Document Number: <u>CY-OC-170-301</u>		Revision: <u>3</u>	
Title: <u>Offsite Dose Calculation Manual for Oyster Creek Generating Station</u>			
<input type="checkbox"/> New	<input type="checkbox"/> Cancel Document	<input type="checkbox"/> Cancel Revision	<input checked="" type="checkbox"/> Revision
EC#: _____		PCR#: _____	PPIS#: _____
<input type="checkbox"/> Editorial		ER#: _____	AR#: _____
<input type="checkbox"/> Batch		#: _____	
<input type="checkbox"/> Supersede corporate document(s) List: <u>None</u>			
Revision Summary: <u>Numerous minor revisions as outlined in Attachment 1 of CY-AA-170-3100.</u>			
Attach add'l descript, if req'd _____			
Impact on Operating and Design Margins: <input checked="" type="checkbox"/> N/A			
Attach add'l descript, if req'd _____			
CONFIRM that no commitments (i.e., those steps annotated with CM-X) have been changed or deleted unless evaluated via completion of LS-AA-110 commitment change/deletion form and INITIAL [Preparer]: <u>RA</u>

This activity revises the ODCM CY-OC-170-310 to incorporate the following changes:

SUBJECT: Revision 3 of Offsite Dose Calculation Manual (ODCM) _____

ATTACHMENT 1
ODCM Change Summary Matrix
Page 1 of 2

Figure E-1.
Locations of REMP Stations within a 1-mile radius
of the Oyster Creek Generating Station

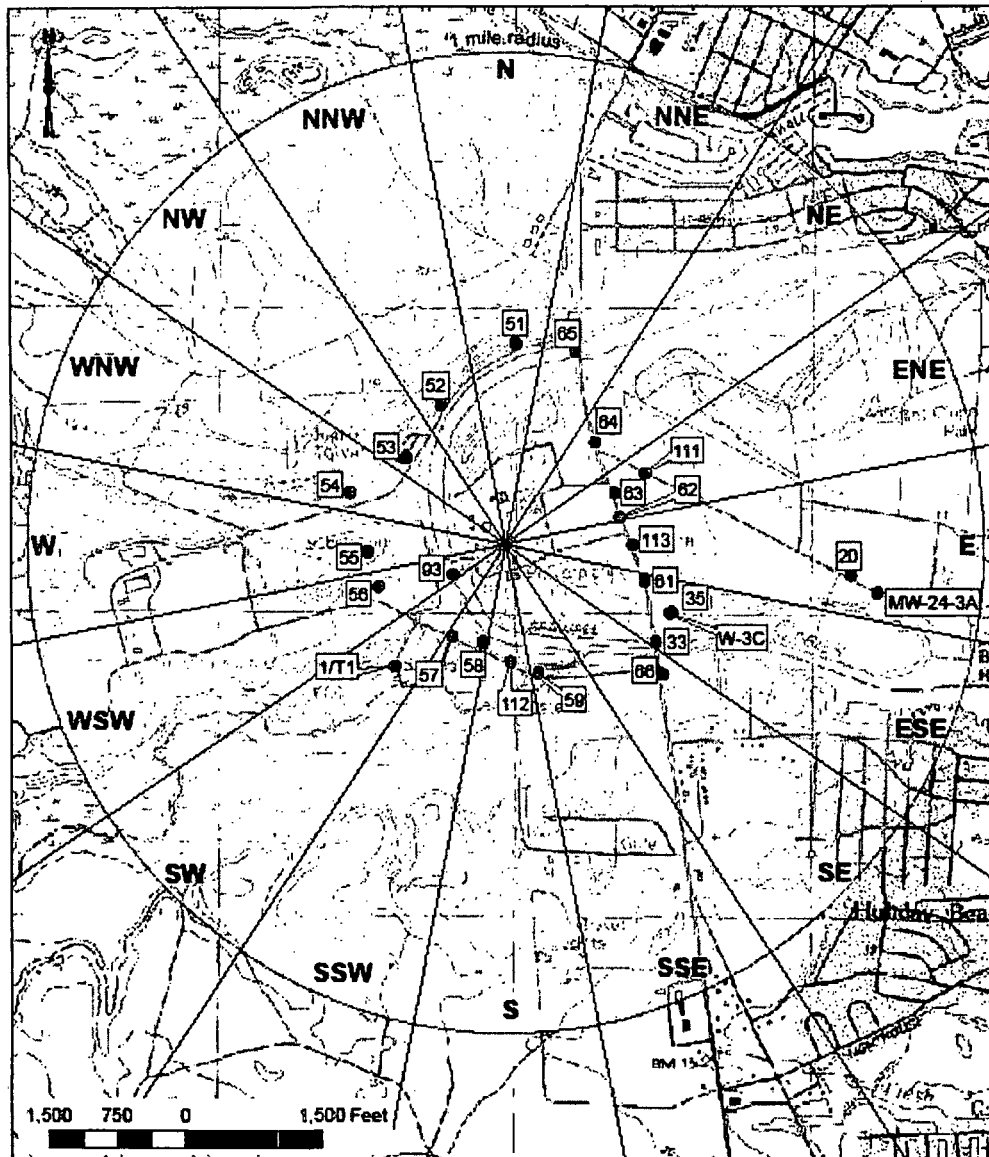
Item No.	(old) Rev. 2 page No.	(new) Rev. 3 page No.	Description of Change
1	7	7	Clarified Figures E-1, E-2, E-3.
2	11	11	Changed Amergen Energy Company to EXELON Generation.
3	48	48	Table 3.12.1-1 For inner ring REMP sample locations, changed "16 locations" to "At least 16 locations." Also changed outer ring REMP stations from "9 locations" to "at least 14 locations."
4	49	49	Table 3.12.1-1 Changed " Three samples from Off Site locations..." to Three samples from close to SITE BOUNDARY..." Also added a clarifying footnote to "least prevalent wind direction."
5	50.	50	Table 3.12.1-1 Changed the sampling and collection frequency from grab sample monthly to " Grab sample weekly, combine into monthly composite."
6	51	51	Table 3.12.1-1 Changed sample location from "One sample from downstream area" to " One sample from downstream area with existing or potential recreational value."
7	53	53	Table 3.12.1-1 Changed "One sample of similar broad leaf vegetation grown distant and in a low location..." to "One sample of each of the similar broad leaf vegetation grown at least 15 to 30 km (9.3-18.6 miles) distant in the least prevalent wind direction."

Figure E-3.
Locations of REMP Stations greater than 5 miles
from the Oyster Creek Generating Station

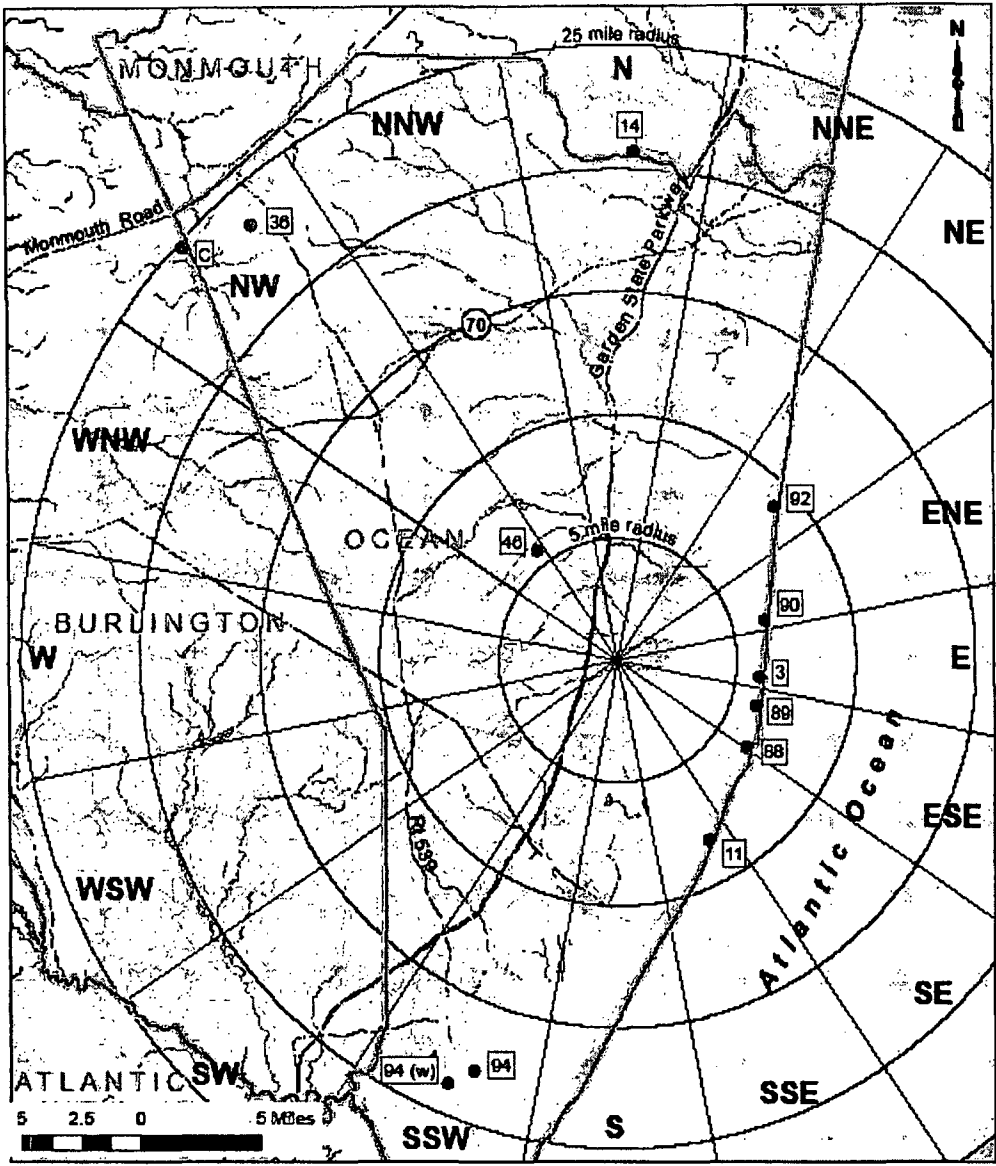
22	97, 98	97, 98	Used updated value of D/Q in example calculation in Section 2.5.3.2.
23	99	99	Used updated value of X/Q in example calculation in Section 2.5.3.4.
24	104	104	Used updated value of D/Q in example calculation in Section 2.5.4.2.
25	121	122	In Table C-1 – References, added reference 31 for Conestoga Rovers and Associates, Hydrogeologic Investigation Report.
26	128	129	In the cover page to Appendix E, added Figure E-4 showing the site layout.
27	129 to 134	130 to 136	Complete re-write of Table E-1 describing REMP sample locations.
28	135	137	Figure E-1 Substituted a new map of REMP stations within a 1-mile radius of the Oyster Creek Generating Station
29	136	138	Figure E-2 Substituted a new map of REMP stations within a 1 to 5-mile radius of the Oyster Creek Generating Station.
30		139	Figure E-3 Inserted a new map of REMP stations greater than 5 miles from the Oyster Creek Generating Station.

FIGURE E-4

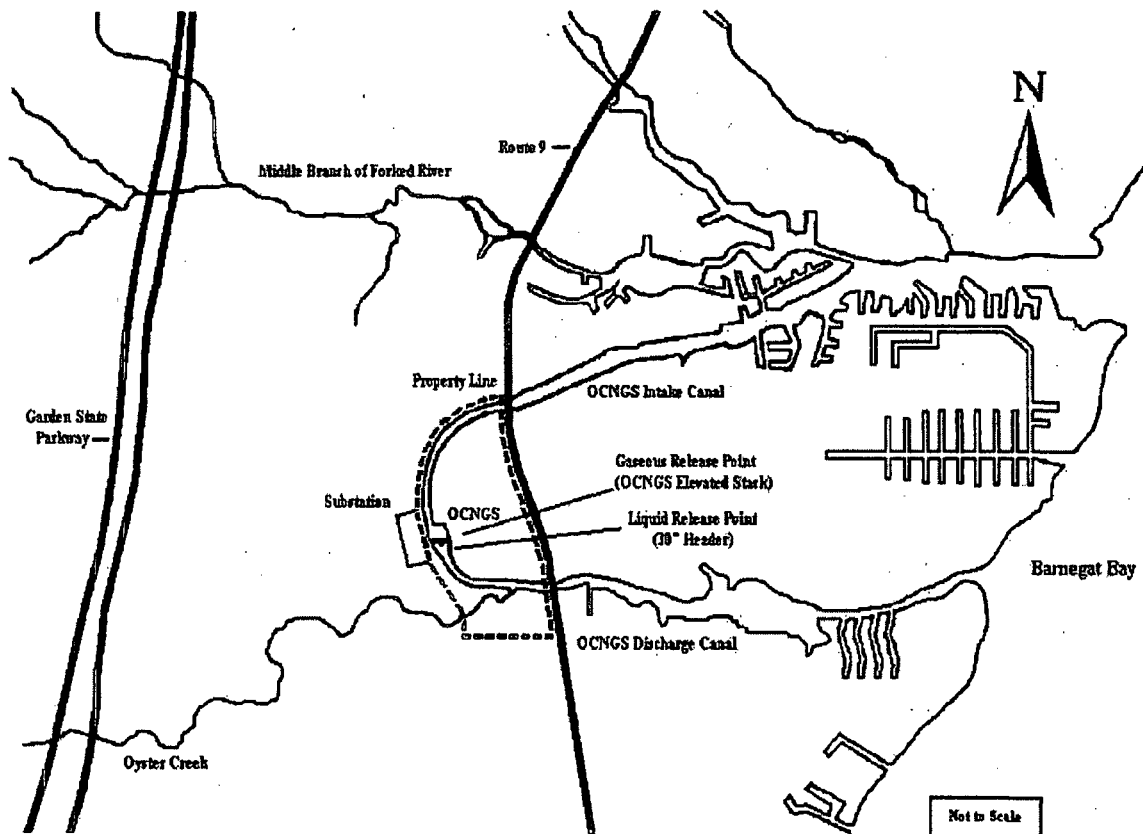
31	137	140	Moved the area plot plan of the site to Figure E-4.
